| <b>Project Title:</b>   | Black Rock Geothermal Project (BRGP)                    |
| <b>Document Title:</b>  | BHER BRGP 23-AFC-03 DA Supplement Set 2 06-20-23        |

# Data Adequacy Supplement, Set 2

Black Rock Geothermal Project  
(23-AFC-03)  
June 20, 2023

**Figure DA 5.2-1a**  
**Biological Study Area**  
**Black Rock Geothermal Project**  
Imperial County, California

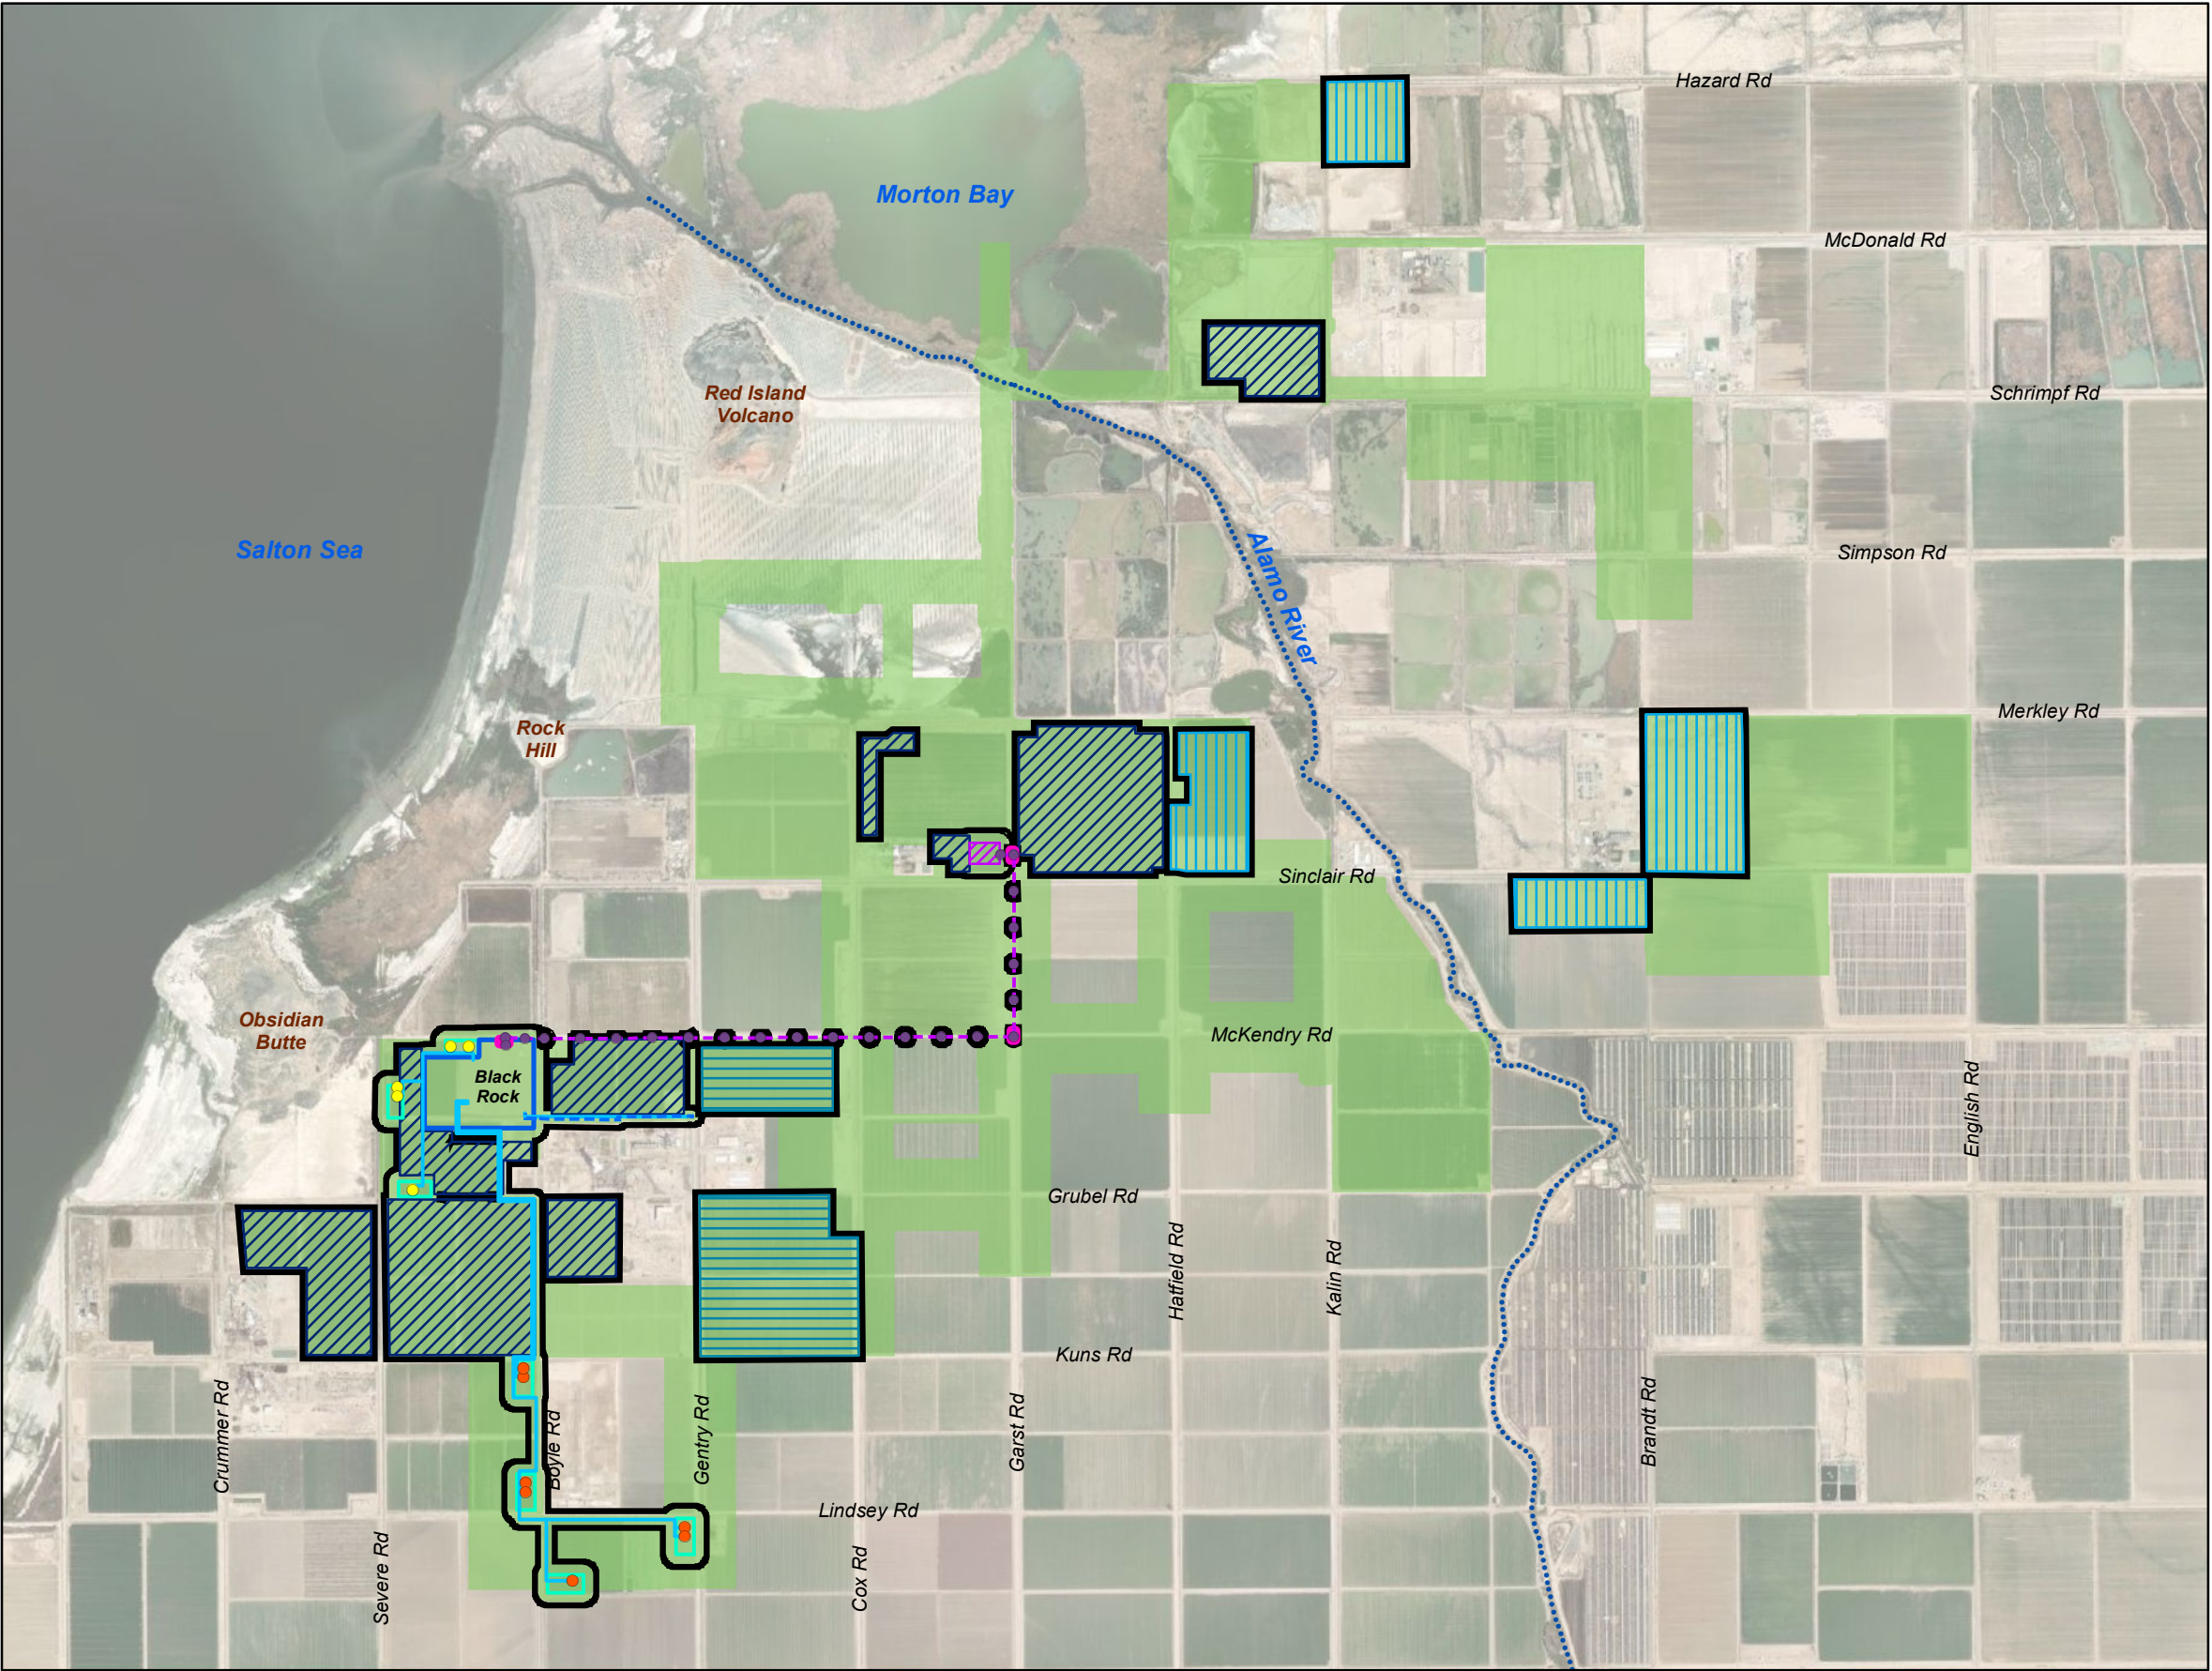
- a) *From Section 5.2.1 on page 170 in the second paragraph, staff has identified some discrepancies that need addressing. There is a discrepancy as to what is defined as the "project", which thus has affected how surveys have been conducted and even how survey buffer zones have been applied. This would have a direct effect on impacts and mitigation possibly required as well as permits. Please explain why "construction laydown, construction camps, borrow pits, parking lots, and pull sites" are not considered as part of the project and surveyed in the same way as the power plant boundary, gen-tie line, etc. that are considered project components.*

**Response:** Surveys were conducted over a larger area (shaded green on Figure DA 5.2-1 provided in Appendix DA 5.2-1a) to assist the Applicant in locating Project features to avoid sensitive biological resources during the preliminary engineering phase.
